Y BRYN WIND FARM

RESPONSE TO SCOPING REPORT IN RELATION TO LANDSCAPE AND VISUAL AND CULTURAL HERITAGE MATTERS

Final Report

Neath Port Talbot County Borough Council

Diagram A: Comparison of turbine size

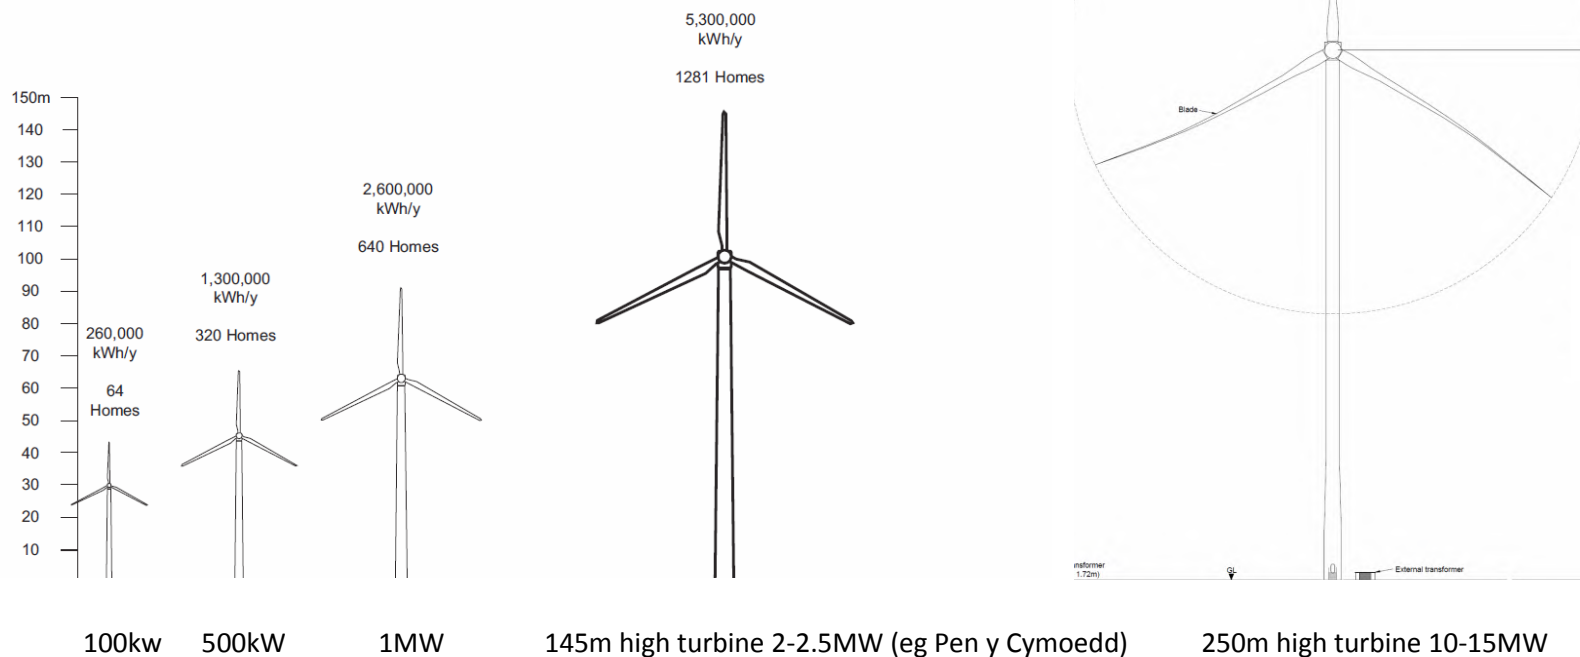
- 4.1. The proposed major development on the site offers many challenges. Relevant key issues include:
- The proposed 250m height of the turbines (see **Diagram A**) is far larger than any other in Wales, and greater than the highest in the UK- 200m at Lethans which is located in Scotland in an area that is rural, larger scale and with far fewer settlements and apparently fewer sensitive receptors. Lethans was consented on a site where permission for smaller wind turbines had already been given.
 - The potential for turbines of this size to be out of scale with the landform on which they sit are of concern so close to well populated valleys, the coast and sensitive receptors.

Extract from TAN8 Annex C below with addition of 250m turbine size proposed to the right but **not** illustrated in report.
